# **Product Change Notice**

Micron PCN: 31192
Date: 4/28/2014

## 11.5x13 Tray Change PCN Support Documentation

### Current Tray Design (11.5x13mm RevA): Existing Design

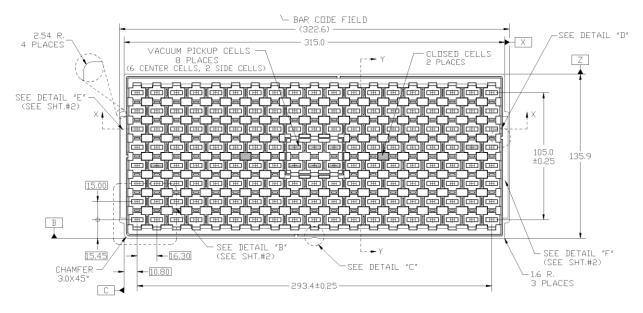
**Description:** New thin components require a change to the current 11.5x13 pocket design. **Current Tray:**

- Pocket Design Ball Support Pocket
- Fence Design Side Side Capture
- Matrix 8x19
- M1 10.80mm
- M2 16.30mm
- M 15.45mm
- M3 15.00mm
- Z Pocket Depth (from top of tray) 1.87mm

- Pocket Design Ball Support Pocket No Change
- Fence Design 6-Fence Interlocking New Fence Design
- Matrix 8x19 No Change
- M1 10.80mm No Change
- M2 16.30mm No Change
- M 15.45mm No Change
- M3 15.00mm No Change
- Z Pocket Depth (from top of tray) 1.87mm No Change

New Tray Design (11.5x13mm RevB): New Design
